**Subject:** RE: SP-22-00004 Willard - Notice of Application

Project: Willard Short Plat Permit#: SP-22-00004 Date: 04/28/2022

RE: SP-22-00004 Willard

SUBJECT: SP-22-00004 Willard Preliminary Short Plat Comments

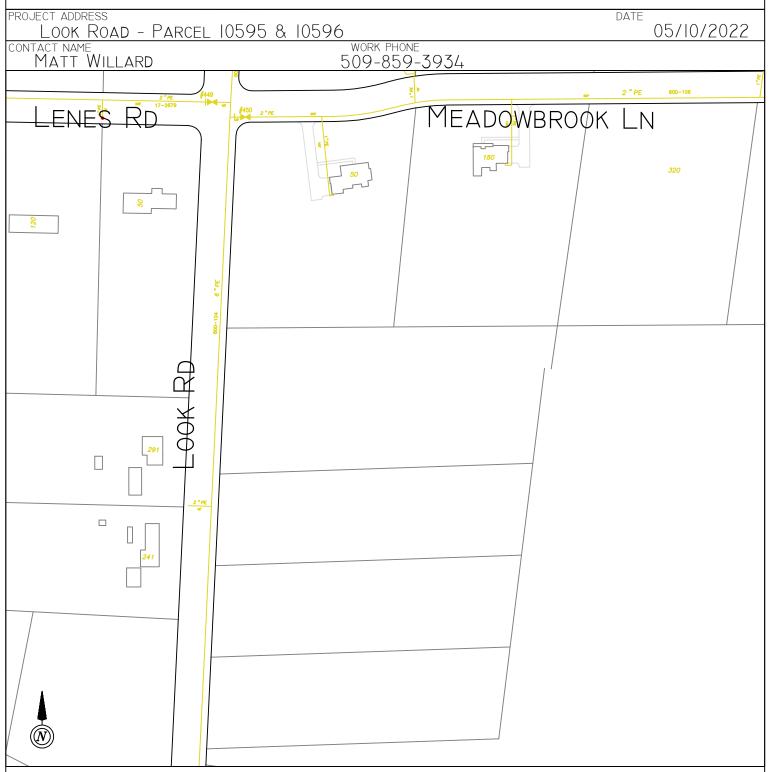
There is a natural gas utility map attached showing the existing natural gas infrastructure in the vicinity of the proposed short plat.

There is no requirements at this time in regards to the creation of lots. However, if the lots are to be developed in the future, each lot will be required to have a gas stub. At that time, the developer will need to work with the City Gas Division to coordinate the construction and layout of the gas facilities.
